CCMC Flood Control Project Steering Committee

The **CCMC Flood Control Project Steering Committee** met Monday, November 9, 2020, at 3:00 p.m. meeting took place over zoom. Present were Committee Members Floodplain Administrator (FPA) Samantha Malenovsky, City Councilperson (CCP) Austin Lott, Custer County Commissioner (CC) Jason Strouf, Public Works Director (PWD) Scott Gray, Grant Writer Ally Capps, (KLJ) Carl Jackson, and (KLJ) Becky Bey.

MILES CITY SECTION 205 FEASIBILITY STUDY
TONGUE AND YELLOWSTONE RIVERS
MILES CITY, MONTANA

Miles City Flood Control Study Minutes
October 26, 2020

Figure 10

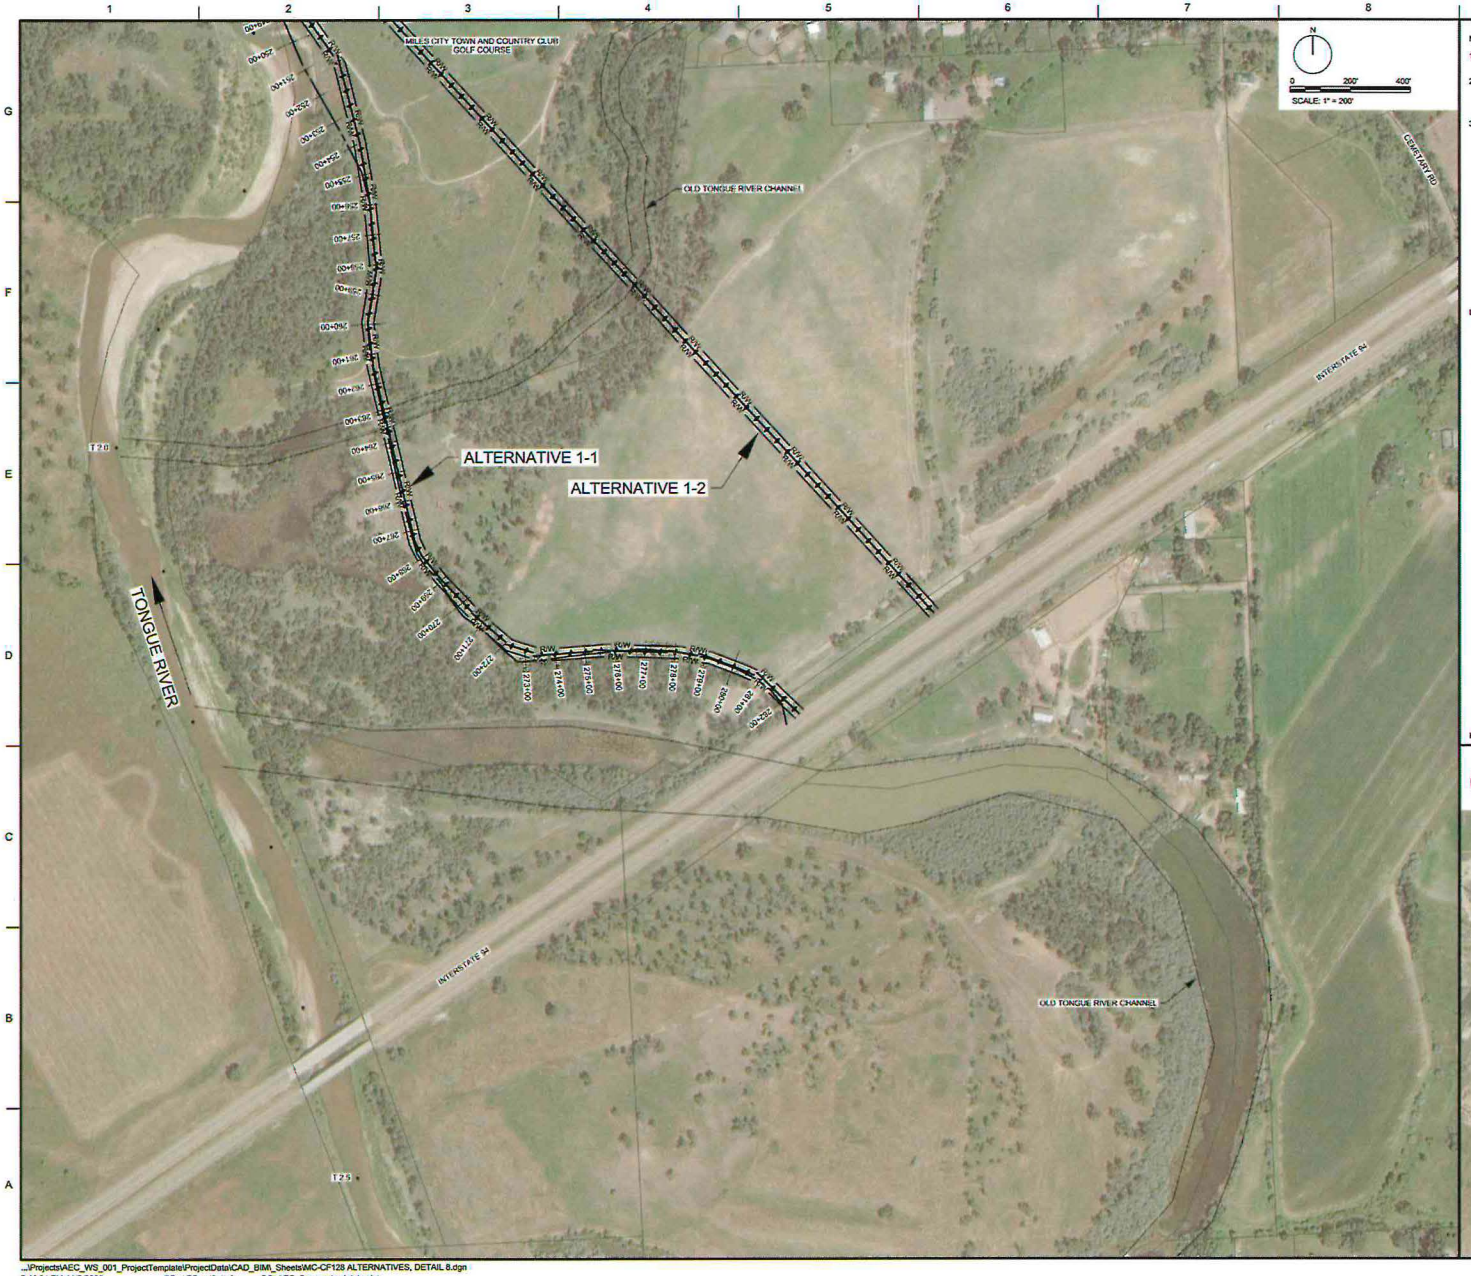
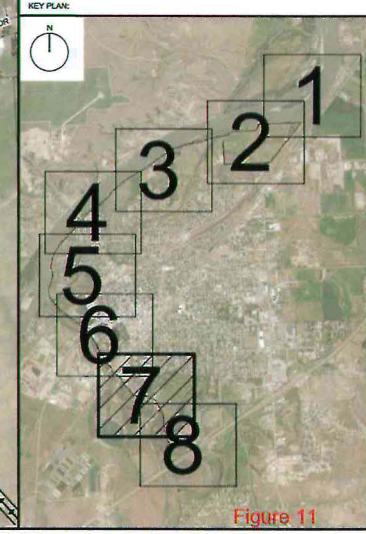
Figures 1-9 in the attached packet is the existing levee footprint. Figures 10 & 11 are for Reach 1 with contain alternatives 1-1 and 1-2. The USACE would like to remove alternative 1-2 as it would affect multiple property owners. The two alternatives were similar in cost but did not include purchase of any property.

***CC Jason Strouf moved to approve the removal of Alternative 1-2 through Reach 1, seconded by Austin Lott. The motion **passed** by unanimous consent, 4-0.*

Alternative 1-2, figure 10 & 11 goes through the middle of Milestown Estates. This was included because we thought it would reduce the levee length and potentially save some money, but the real estate impact would be much greater and could potentially cost more. The USACE thought this alternative could be excluded since there is no additional benefit from setting back further.

Figure 12

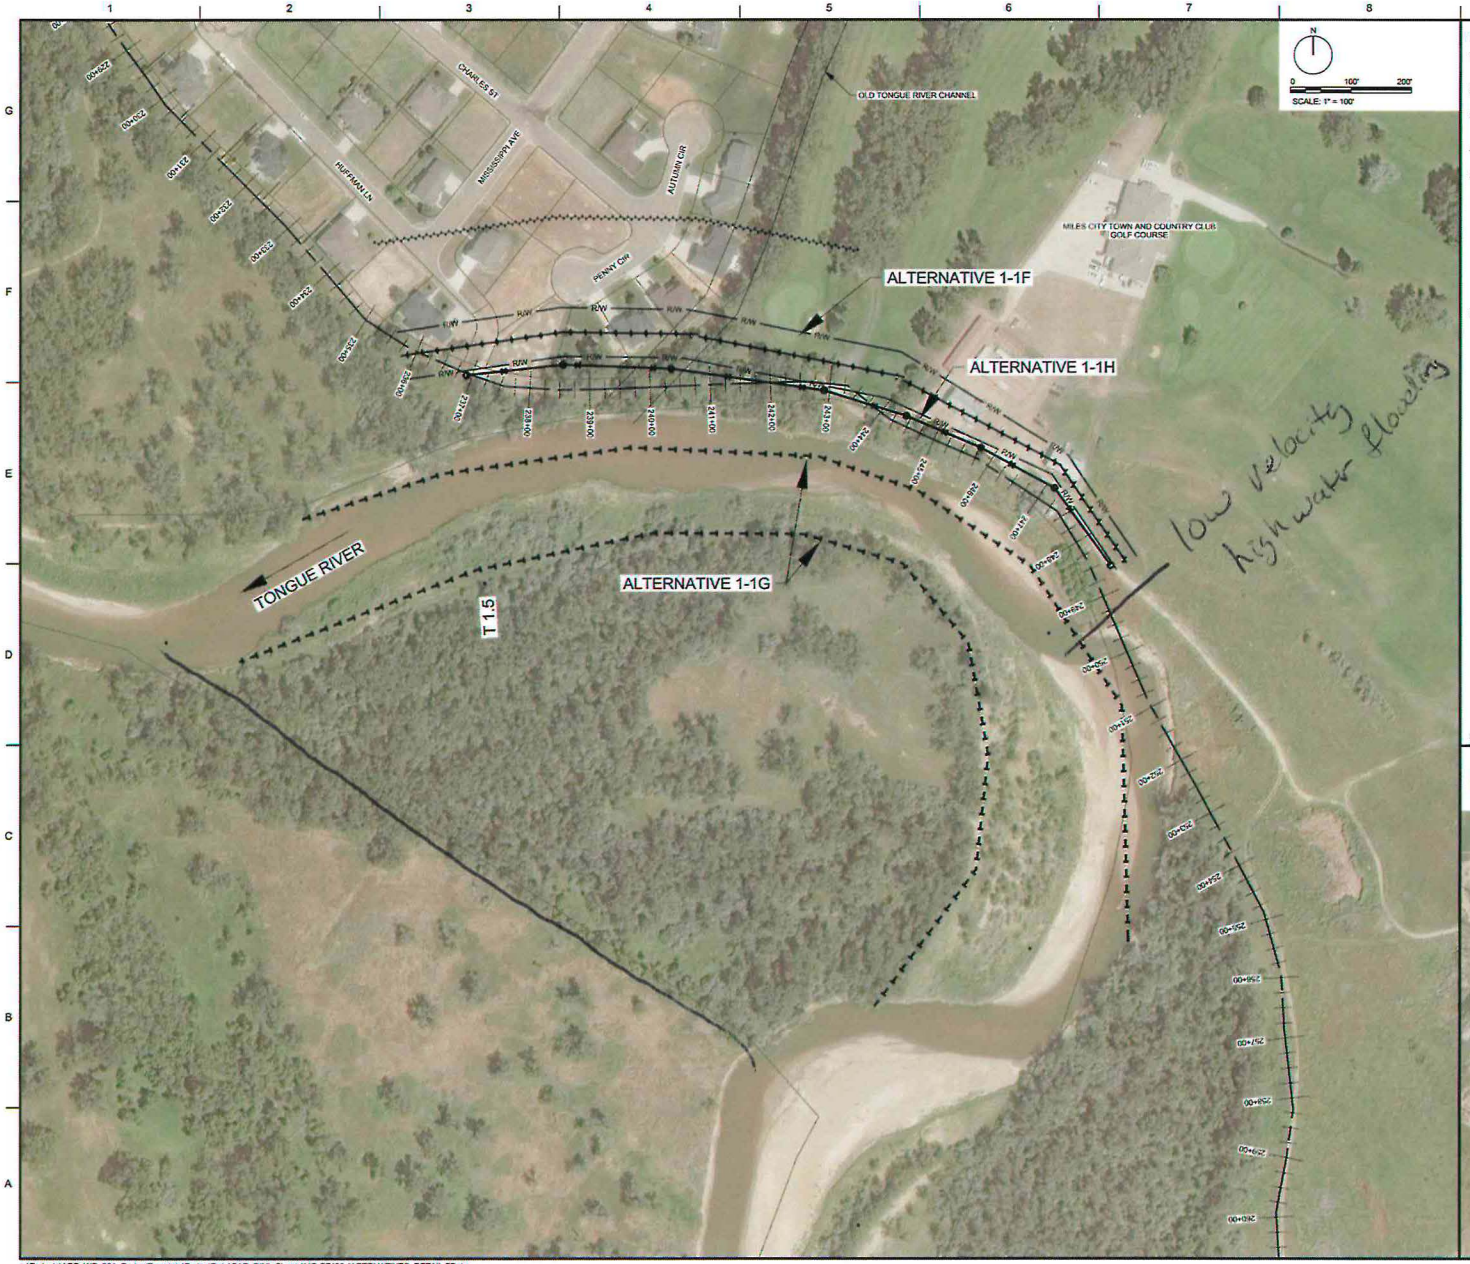
Figure 12 shows further alternatives to Alternative 1-1. Alternative 1-1F moves the levee alignment back to give more room for the river channel and reduces the amount of riprap that would be needed. Alternative 1-1G is a channel realignment which would help relieve pressure on the levee bank and reduce the amount of riprap. Alternative 1-1H is a floodwall which is a smaller footprint, requires less property but is a far amount more in cost. An approximate cost per linear foot of a floodwall is $4,000 which is based on some other recent projects, but with assumptions such as underseepage requirements and wall height adjusted for Miles City. CC Strouf questioned if the channel could be rerouted at the two turns along the tree line, drawing attached. KLJ Jackson stated that this could increase the velocity to the point it could affect downstream flood stage conditions. PWD Gray asked if the channel could be realigned, as stated by CC Strouf, if the oxbow could be used for highwater storage.

There were also other possibilities added to alternative 1-1. Alternatives 1-1F, 1-1G and 1-1H are along the southern portion bend in Milestown Estates. Alternative 1-1F is a different levee alignment, 1-1G is a channel realignment (which would still require a levee) and 1-1H is a floodwall. Alternatives 1-1B, 1-1C and 1-1D are along the apartment building located at the north side of the Milestown Estates. Alternative 1-1B is a different levee alignment, 1-1C is a channel realignment (which would still require a levee) and 1-1D is a floodwall. Both segments would require more property but may require less of a seepage berm.

Figure 13

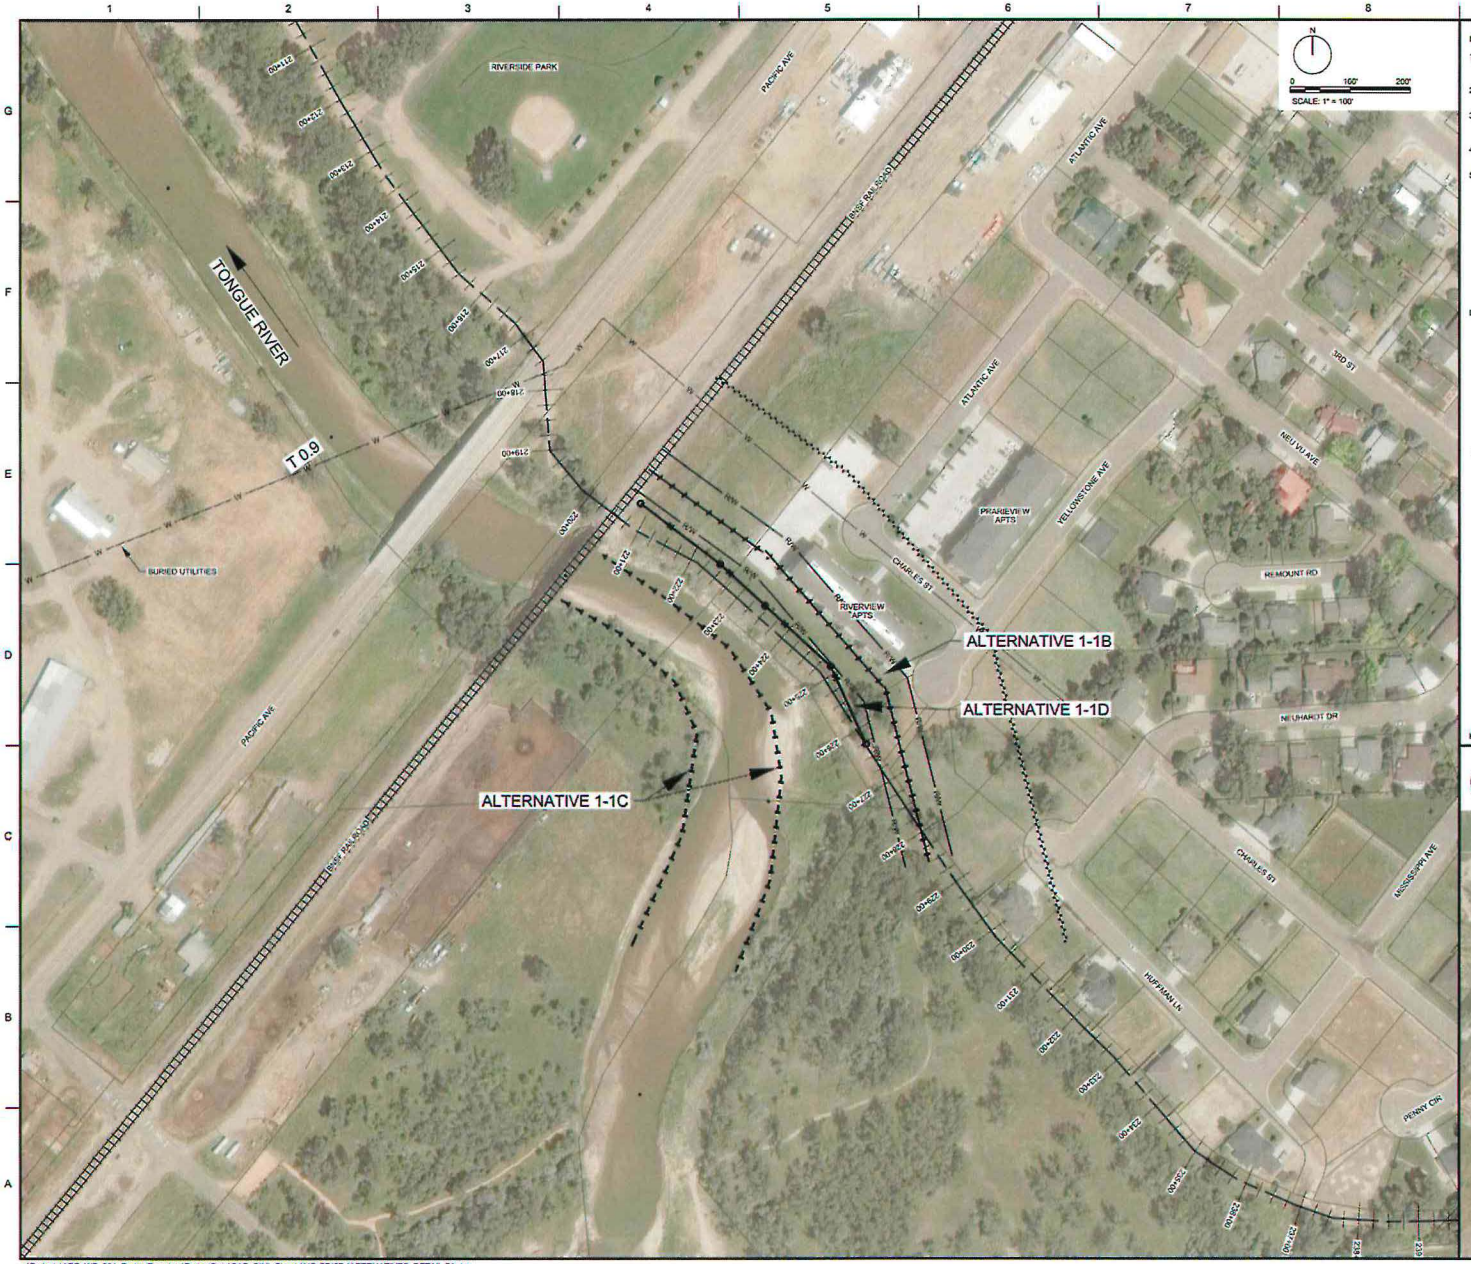
Figure 13 shows some more alternatives to Alternative 1-1. Alternative 1-1B moves the levee alignment back to give further room for the river channel. Alternative 1-1C is a channel realignment to provide further reduction to the levee bank, and Alternative 1-1D is a floodwall that would require less real estate. PWD Gray pointed out that if the channel was able to be straightened out as previously questioned this would be an area where the higher velocity could cause an issue and a floodwall maybe needed.

Figure 14

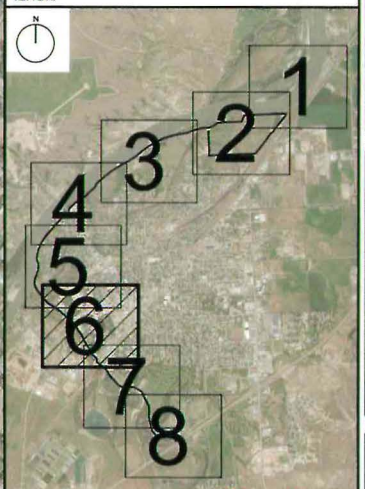
Figure 14 shows Reach 2 with alternatives 2-1 and 2-2, the USACE would like to remove alternative 2-2 as it would affect multiple municipal areas and real estate. Both alternatives were similar in cost but did not include purchase of any property. PWD Gray had some concerns with the amount of public area that alternative 2-1 would consume.

*** PWD Gray moved to approve the removal of Alternative 2-2 through Reach 2, seconded by CC Jason Strouf. The motion* ***passed*** *by unanimous consent, 4-0.*

Alternative 2-2 goes across the ball fields and impacts Riverside Park. The USACE thought alternative 2-2 could be excluded since there is no additional benefit from setting back further and the impact to community property would be greater.

Figure 15

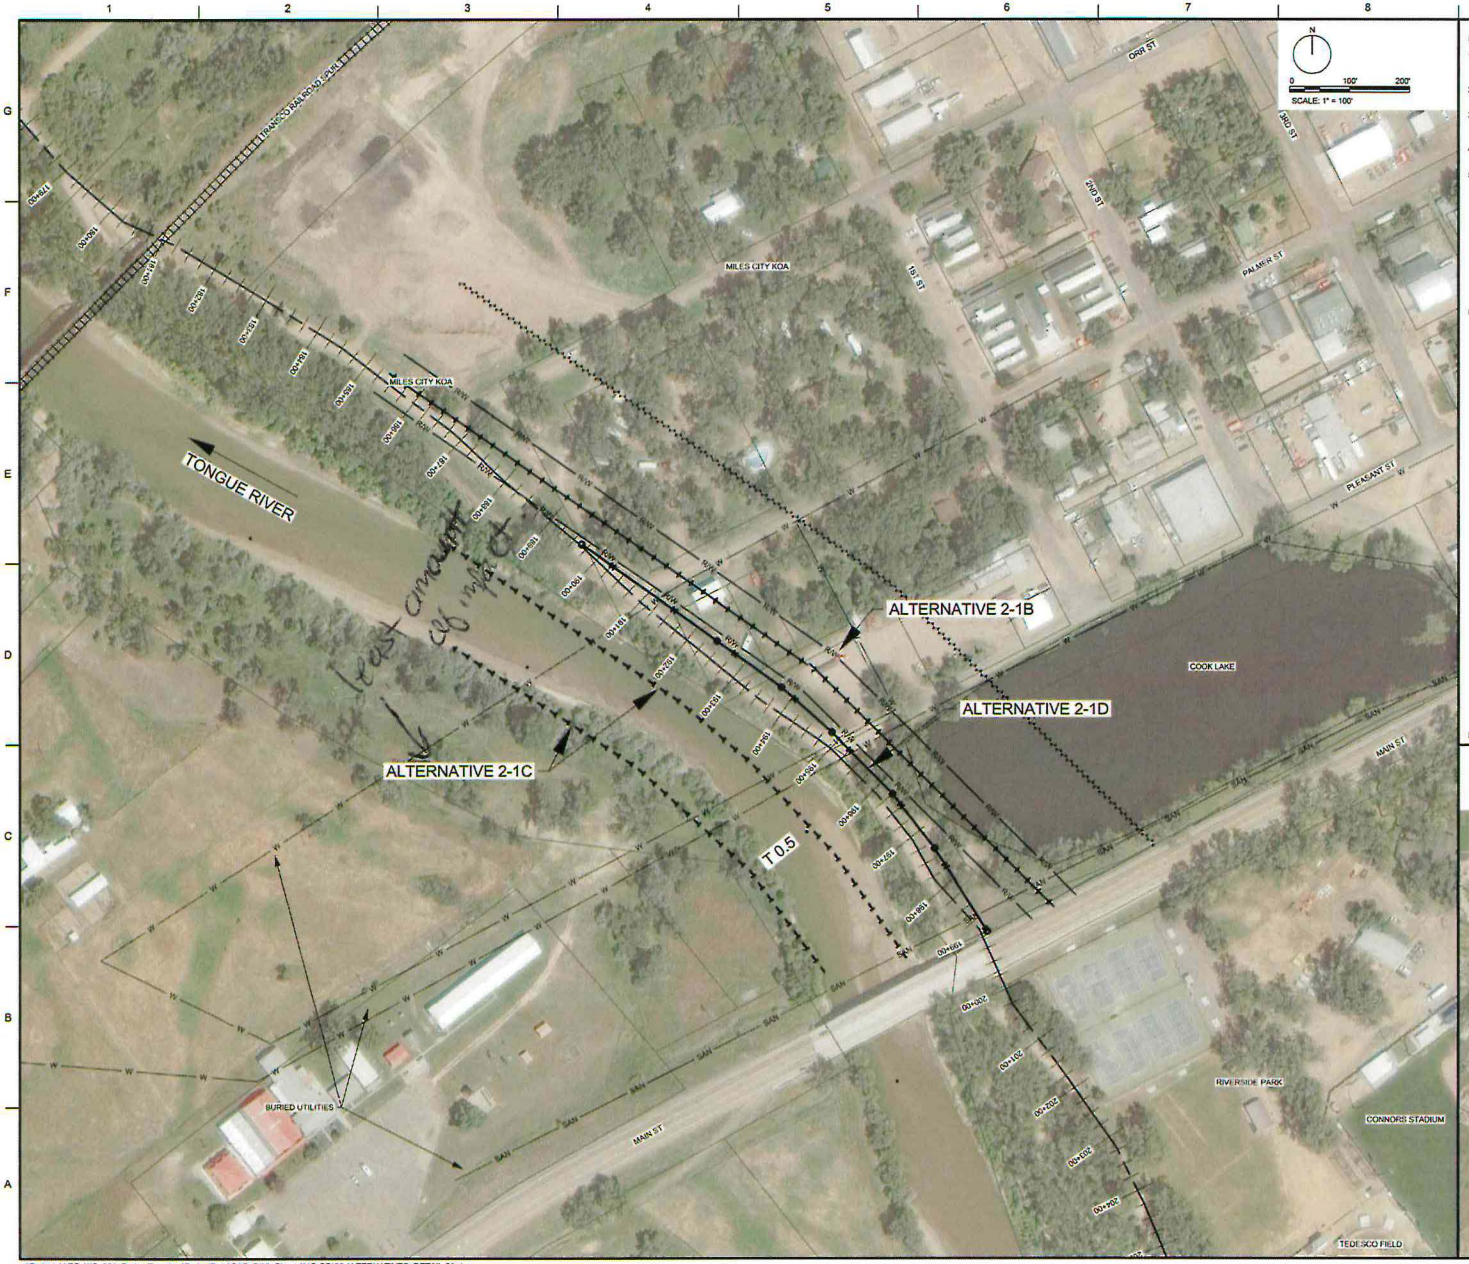
Figure 15 shows three alternatives within Alternative 2-1. Alternative 2-1B is a setback levee to give further room for the river channel. Alternative 2-1C is a channel realignment which would help reduce the impact of high waters on the levee wall and reduce the amount of riprap needed. Alternative 2-1D is a floodwall which is a higher cost but requires less real estate and may not require the mitigation of the wetland, Cook Lake. PWD Gray, CC Strouf, and CCP Lott prefer alternative 2-1C since a channel realignment could be the least amount of impact to property, this is actually preferred amongst all the committee members in the majority of the realignment alternatives. There is concern among the committee members on the utilities lines that run under the river in this area and how sheet pilling could affect the depth of the lines.

Alignments in Reach 2 (from BNSF RR Bridge to Old Milwaukee Bridge):
There were two alternatives in this area. Alternative 2-1, figures 14 & 15 mainly follows the existing levee. The additional alternatives 2-1B, 2-1C and 2-1D was added to alternative 2-1 from Main street to just north of the KOA campground. This was due to some erosion that has occurred in the area throughout the years. If the community choose alternative 2-1 then additional riprap would be required for strength. There is also the option of a small channel realignment to the west of the current levee to help relieve some of the pressure and erosion issues.
